Subject: VLO-24-02 44 E. Flint, Site Plan Review #2

We have received a site plan application from Jeff Schmitz (the “applicant/developer”) for the construction of a ±6,700 square feet, 4-story mixed-use building located at 44 E. Flint Street (the “project”). The project is in the Downtown Center (DC) District and Height Overlay District on the southwest corner of E. Flint Street and S. Anderson Street. The project is situated on two parcels (09-02-481-007 and 09-02-481-008). In July 2021, the developer received site plan approval for the construction of a paid parking lot within the project area.

Re: 44 E. Flint Street
Site Plan Review #2
NFE Job No. N930

Architectural Site
Plan

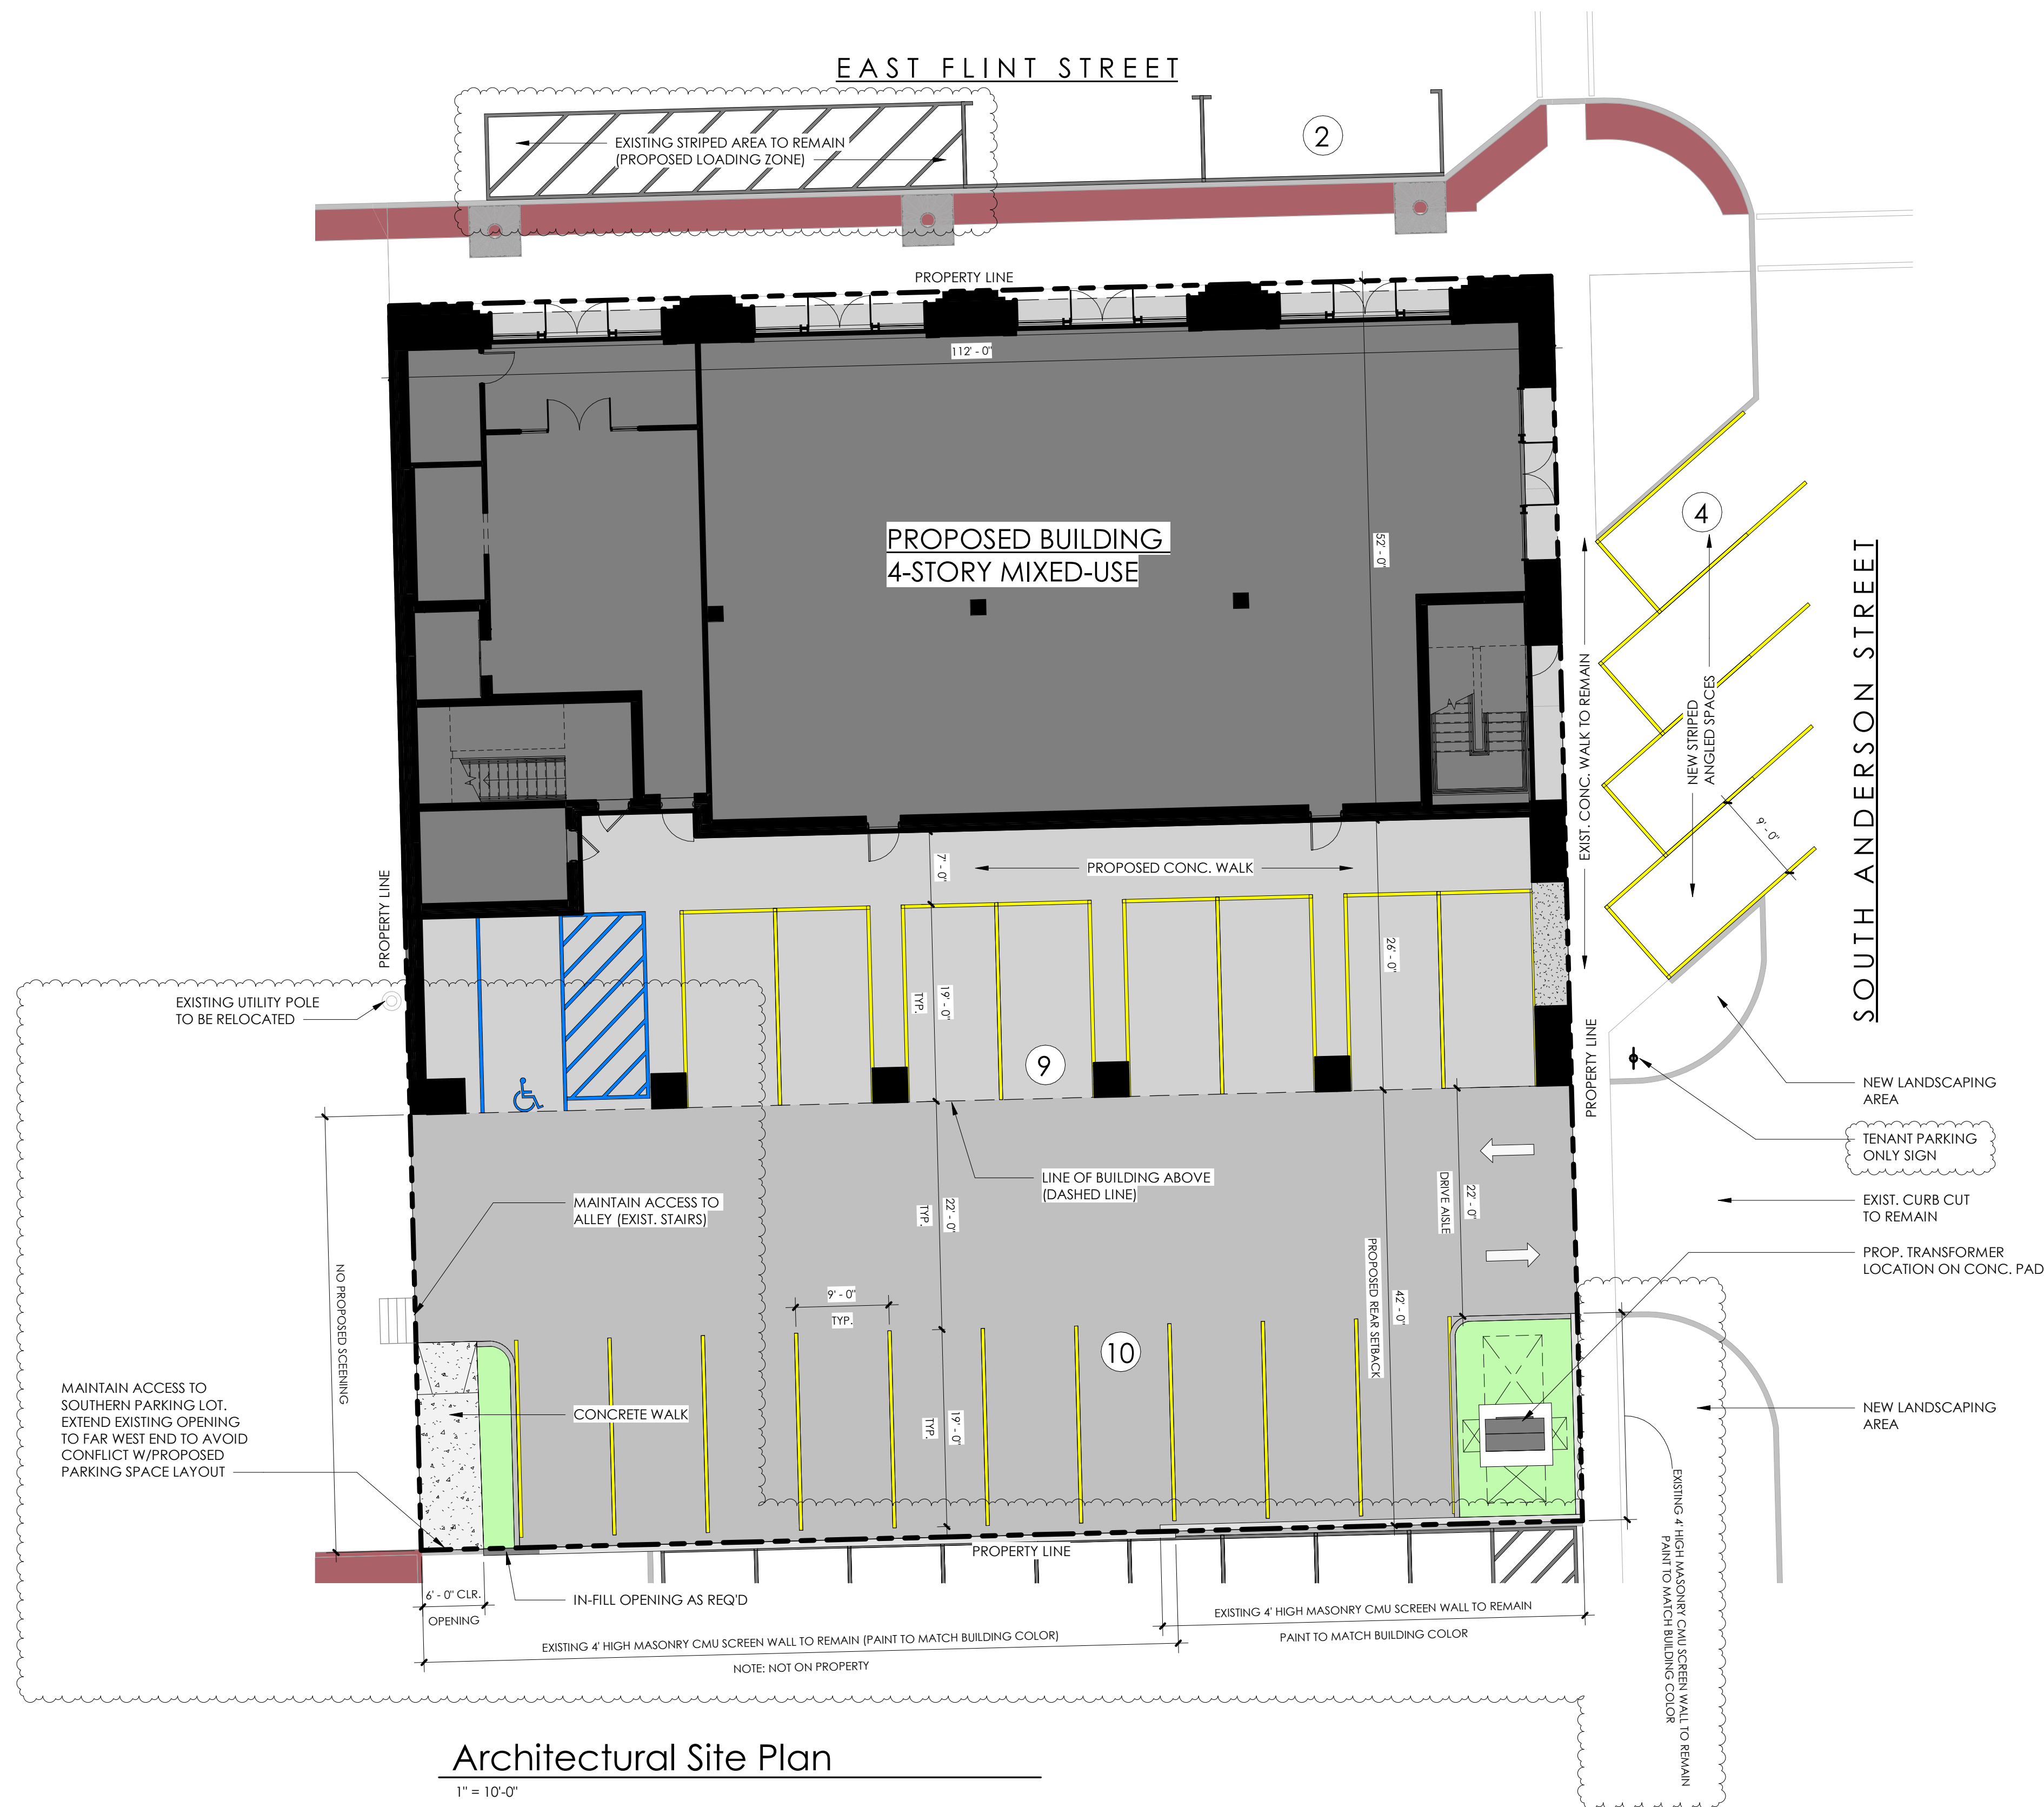
12. The nearest hydrant is now shown as required, located at the SE corner of Flint and Anderson.
13. We note that the engineering site plans and architectural site plans are not completely consistent with one another, in particular at the southwest corner of the site where access to the trash enclosure is proposed and at the power pole on the west property line, where architectural plans call for its relocation. This pole is located offsite; any offsite work will require a temporary construction easement from the affected parcel(s).

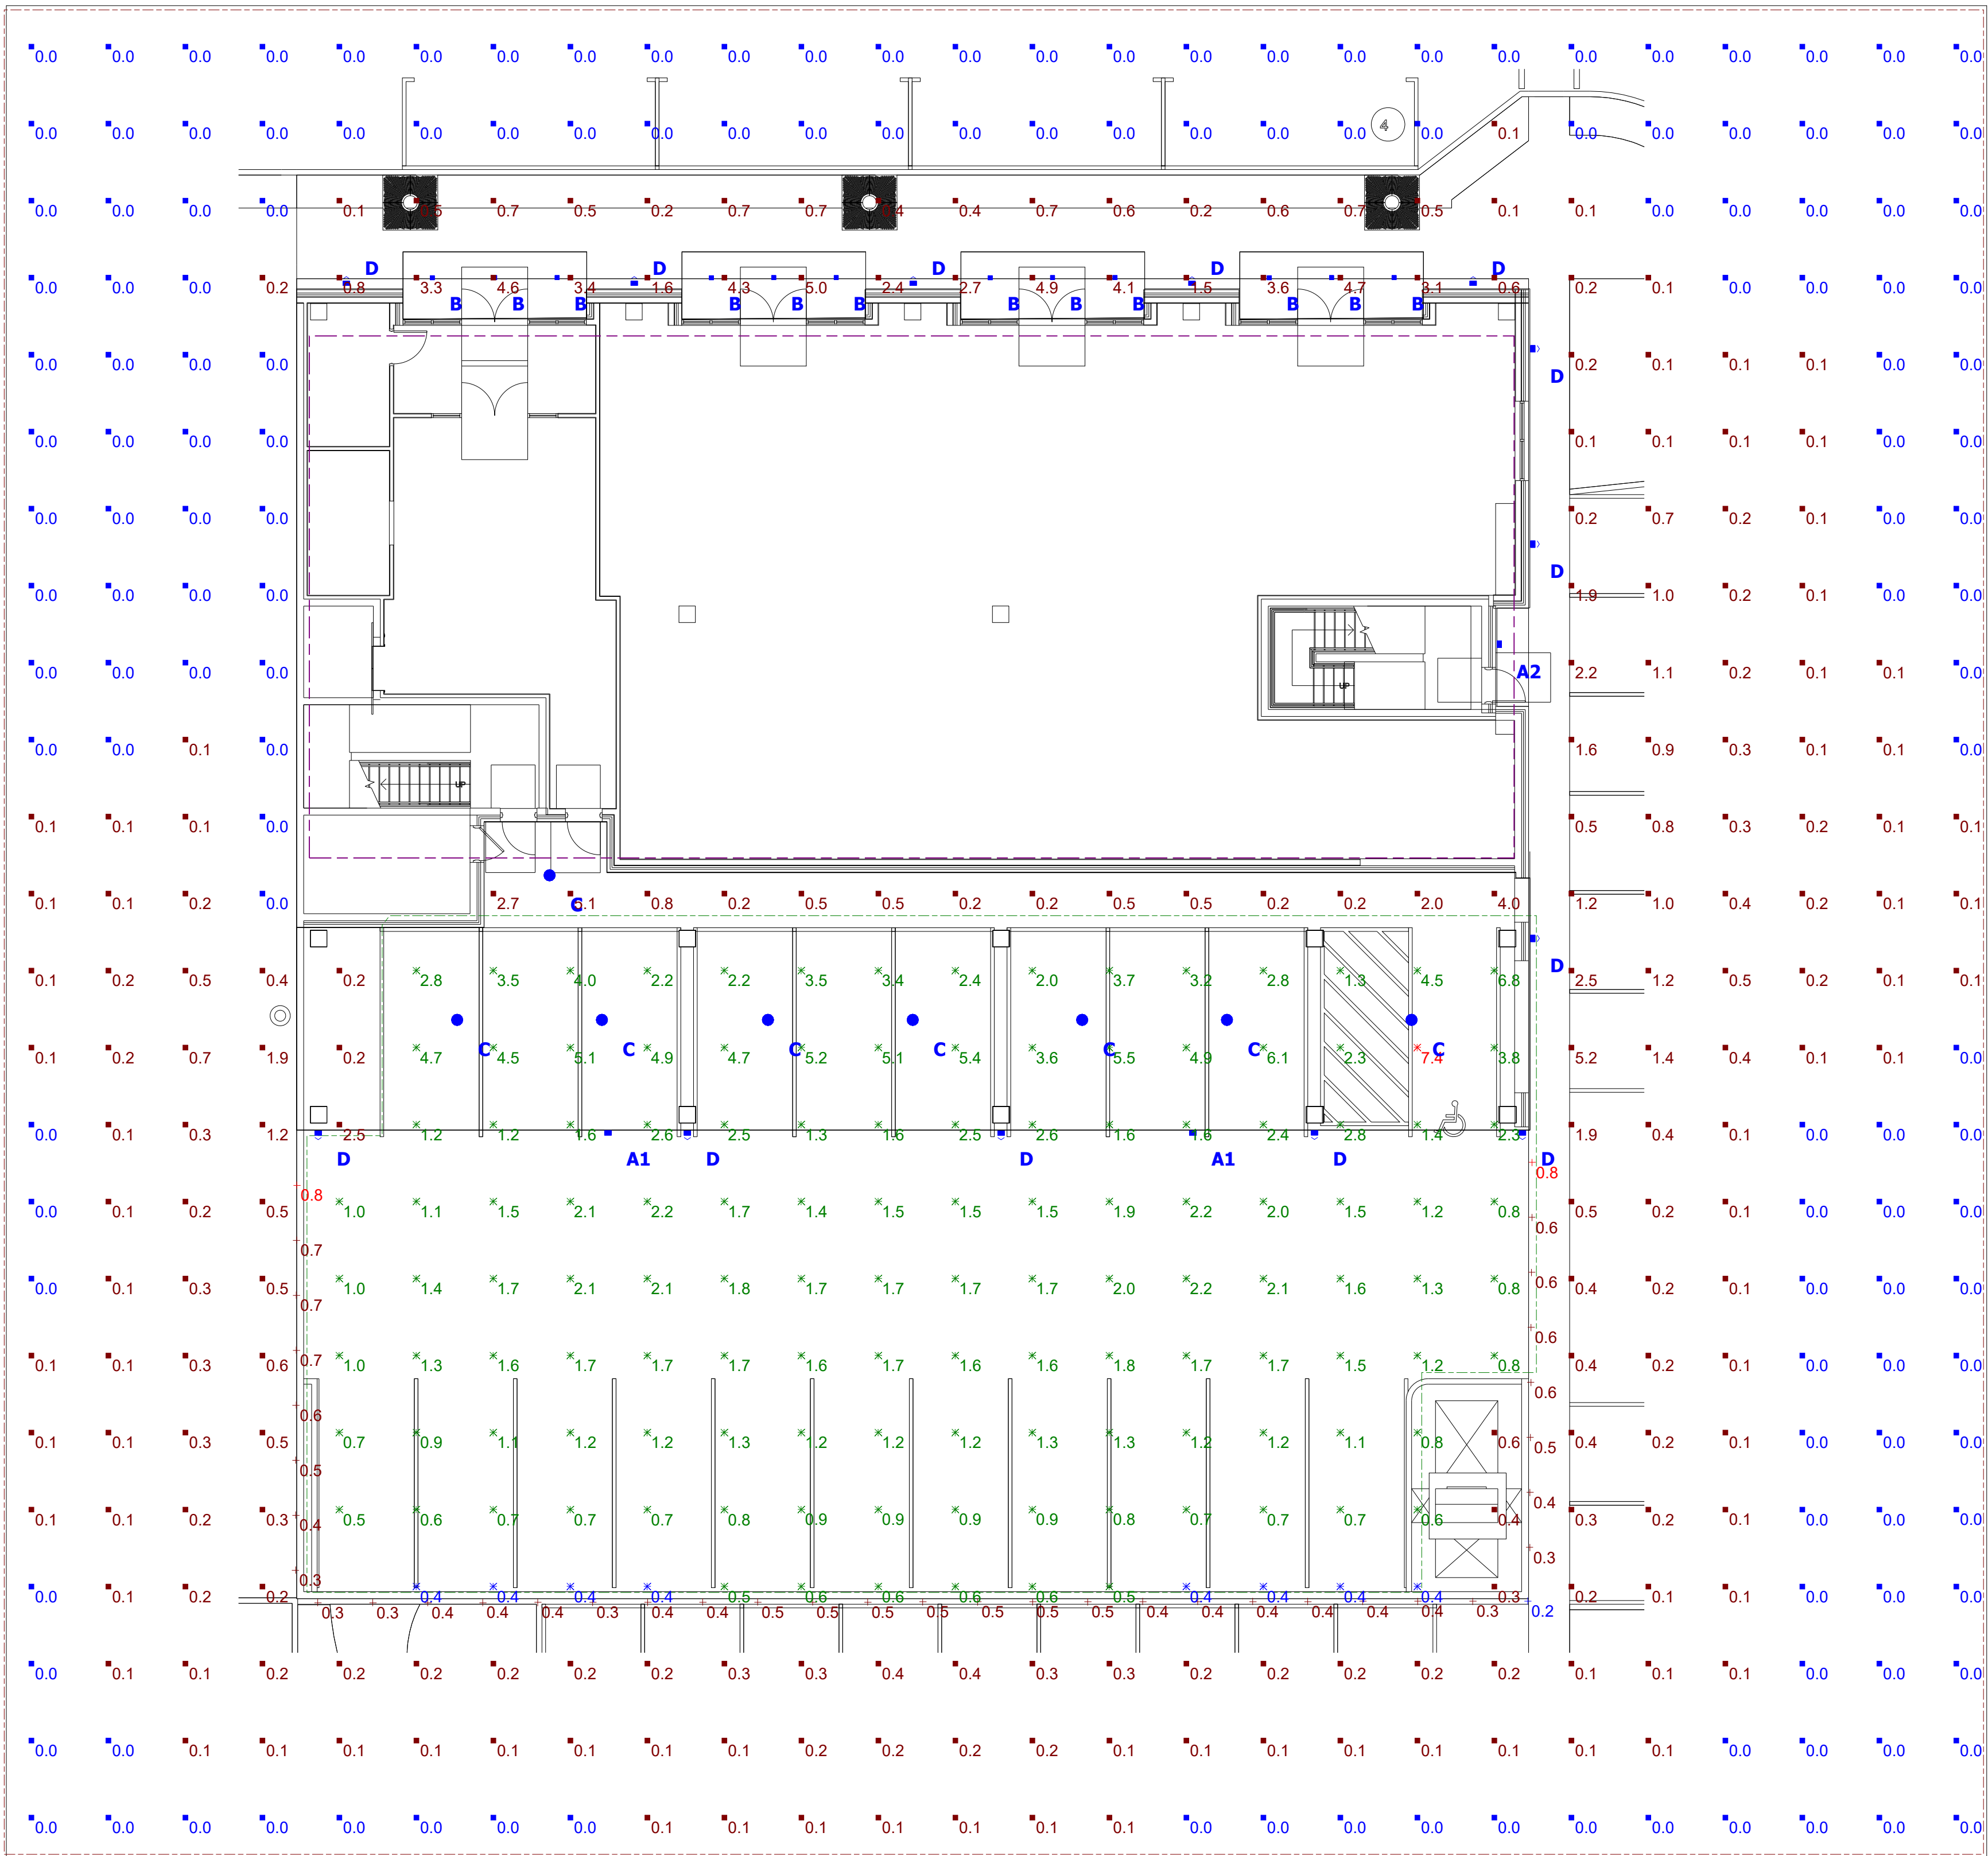
The Planning Commission may modify lighting requirements in considering possible off-site impacts and the character of the proposed use. We recommend that the lighting along Anderson be reduced to 1.0 fc at the street edge of the sidewalk, to minimize off-site impacts. We recommend the Planning Commission grant a waiver for the proposed illumination levels along Flint, which serves as a primary downtown corridor.
